### 5.1. CONSIDERATION OF APPLICANT REPRESENTATIONS FOR RECONFIGURATION OF A LOT (ONE LOT INTO 39 LOTS), NEW ROAD AND BALANCE LAND

<b>REPORT AUTHOR</b>	Jenny Elphinstone, Senior Planning Officer
<b>MANAGER</b>	Paul Hoyer, Manager Environment and Planning
<b>DEPARTMENT</b>	Environment and Planning
<b>APPLICATION NO</b>	ROL 2021_4012/1
<b>PROPOSAL</b>	Applicant representations for a Negotiated Decision Notice for the Reconfiguring a Lot (One lot into 39 lots), New Road and Balance Land.
<b>APPLICANT</b>	Port Douglas Land Developments Pty Ltd C/- Cardno, PO Box 1619, Cairns Qld 4870
<b>LOCATION</b>	Captain Cook Highway Craiglie
<b>PROPERTY</b>	Lot 2 on SR 431
<b>PLANNING SCHEME</b>	2018 Douglas Shire Council Planning Scheme Version 1.0
<b>ZONING</b>	Low Density Residential Zone
<b>LEVEL OF ASSESSMENT</b>	Code
<b>PROPERLY MADE DATE</b>	1 February 2022 (Change representations received)
<b>STATUTORY ASSESSMENT DEADLINE</b>	Agreement to extend applicant's suspended appeal period to 31 March 2022
<b>REFERRAL AGENCIES</b>	State Assessment & Referral Agency – not required for consideration of representations

Figure 4 – Intersection works as identified by DTMR

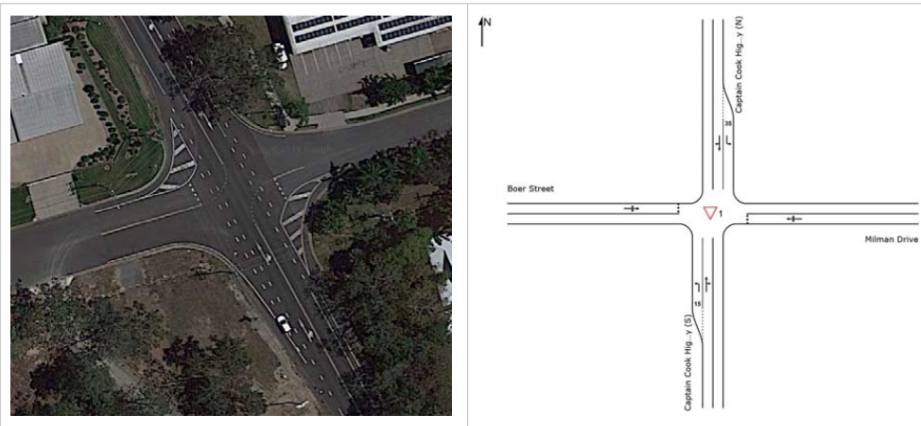
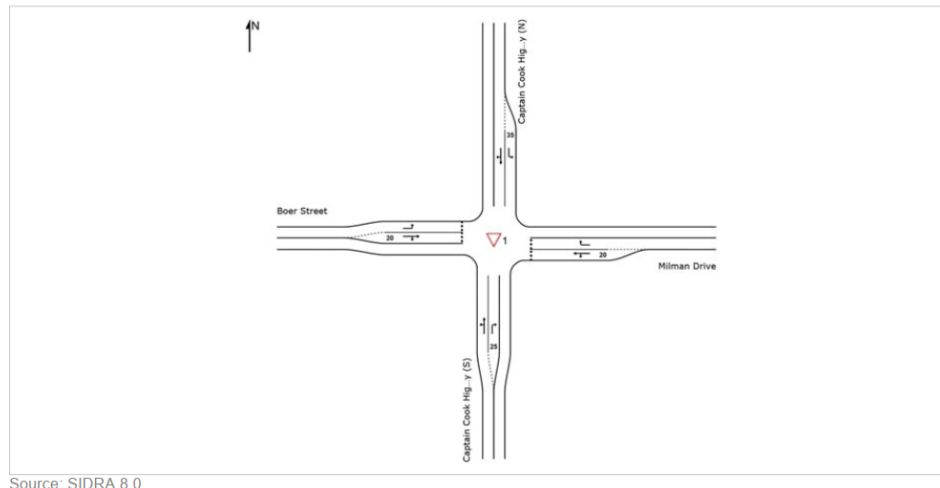
The pre-development traffic volumes detailed in the Road Safety Audit undertaken by Cardno, as part of Stage 1 of the development, indicate that 59 vehicles exit Beor Street East in the morning peak hour. With the addition of traffic generated by Stage 1 & Stage 2, in accordance with the traffic analysis submitted by the applicant, the volume would increase by an additional 39 vehicles i.e. 70% increase in traffic. The applicant's traffic report from Stage 1 specifically identified the need to reconfigure the Captain Cook Highway / Milman Drive (Beor street) intersection to include the following, regardless of the development yield:

- *Major right turn lane and minor left/through short lane on the eastern approach*
- *Major left/through lane and minor short right turn lane on the southern approach*
- *Major left turn and minor short through/right lane on the western approach; and*
- *Northern approach unchanged."*

These requirements are included in the diagrams below.

The condition currently requires an auxiliary left hand turn out lane to assist movements from the local network that head south. There appears to be sufficient land available in the road to enable this outcome. The applicant has not made representations asserting that there is insufficient area in the road to achieve this outcome. The applicant seeks to amend the requirement to be less specific on the outcome as a changed situation to the current movements and to be exclusively reliant on an external reviewer who is engaged by the developer. The additional stand up lane is therefore required to mitigate this impact and the requirement.

The applicant's assessment report identified upgrades required as identified below. However, the SARA condition only requires a Channelised right-turn treatment with a short turn slot (CHR(S)) two lane rural road for north bound vehicles turning right from Captain Cook Highway into Boer Street. There is no clarification regarding the remainder of the works to the intersection.

Design and undertake construction of an upgrade to Beor Street (east) for the provision of two approach lanes at its intersection with Captain Cook Highway.

The lane capacity and configuration is to be determined from a revised traffic analysis.

Any review needs to be to Council's satisfaction and that any identified works be consistent with all other required upgrades with all associated costs are borne by the developer. That the design be dependent on for a further review with an "out-clause" is not accepted. The condition has been reworded to include these outcomes.
